# Layout Notes for Connector Board

Connector Prototype Board Details

### OreSat debug pinout proposal.

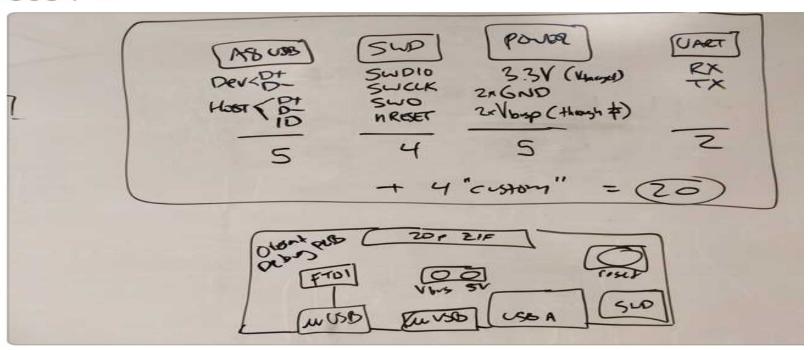
Instead of a 6 pin FTDI cable which is \$19 each, let's actually add another uUSB connector and an actual FTDI USB to serial converter, like an FT232R.

Don't need the mounting holes. We won't be mounting these to anything.

VJTAG should be called "VSER" or "VFTDI" or something.

The 5V for the USB Type A host is provided by the card, so you'll need to add a 5V line.

- Double up the ground line on the main connector (the PAD connector isn't actually connected to anything besides the physical pads).
  - No such thing as "SWD". It's "SWO". And it should be connected to the JTAG connector's SWO.
  - Go ahead and center the FFC connector on the board just because.
- Change to 2 layer OSH Park design rules.
- Don't need the resistors in the USB line.
- Put the part number of the required FFC cable on the schematic.
